United States Patent and Trademark Office

APPLICATION NO.	FILING DATE	FIRST NAMED INVENTOR	ATTORNEY DOCKET NO.	CONFIRMATION NO.	
10/561,058	07/31/2006	Soo Yong Song	05-474-B 1927		
20306 7	0306 7590 10/06/2006		EXAMINER		
MCDONNELL BOEHNEN HULBERT & BERGHOFF LLP 300 S. WACKER DRIVE 32ND FLOOR CHICAGO, IL 60606			CHAMBERS, T	CHAMBERS, TRAVIS SLOAN	
			ART UNIT	PAPER NUMBER	
			2833		
			DATE MAILED: 10/06/200	DATE MAILED: 10/06/2006

Application No.	Applicant(s)				
Office Action Commons	10/561,058	SONG, SOO YONG				
Office Action Summary	Examiner	Art Unit				
	Travis Chambers	2833				
The MAILING DATE of this communication appears on the cover sheet with the correspondence address Period for Reply						
A SHORTENED STATUTORY PERIOD FOR REPLY IS SET TO EXPIRE 3 MONTH(S) OR THIRTY (30) DAYS, WHICHEVER IS LONGER, FROM THE MAILING DATE OF THIS COMMUNICATION. - Extensions of time may be available under the provisions of 37 CFR 1.136(a). In no event, however, may a reply be timely filed after SIX (6) MONTHS from the mailing date of this communication. - If NO period for reply is specified above, the maximum statutory period will apply and will expire SIX (6) MONTHS from the mailing date

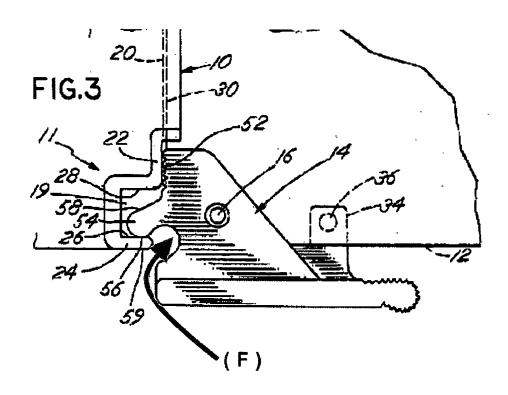
Puri teaches a locker (near lead line 40; Fig. 5) having a lever (64; Fig. 5) formed on the upper part thereof; wherein the lever (64; Fig. 5) causes the card (12; Fig. 3) to be vertically self-erectable on the shelf; a body (B; image below) mounted on the lower part of the locker (near lead line 40; Fig. 1) having a fixing groove (F; image below) shaped as a groove on the lower part thereof, wherein the body (B) is fixed to the guide supporter (24; Fig. 3) having the fixing protrusion (near lead line 56; Fig. 3); and a base (Base; image below) established on one side of the lower part of the body (B) having a coupling protrusion (52; Fig. 5) on the lower part thereof, wherein the base (Base) causes the guide supporter (24; Fig. 3) having the finger strip (59; Fig. 3) to be grounded.
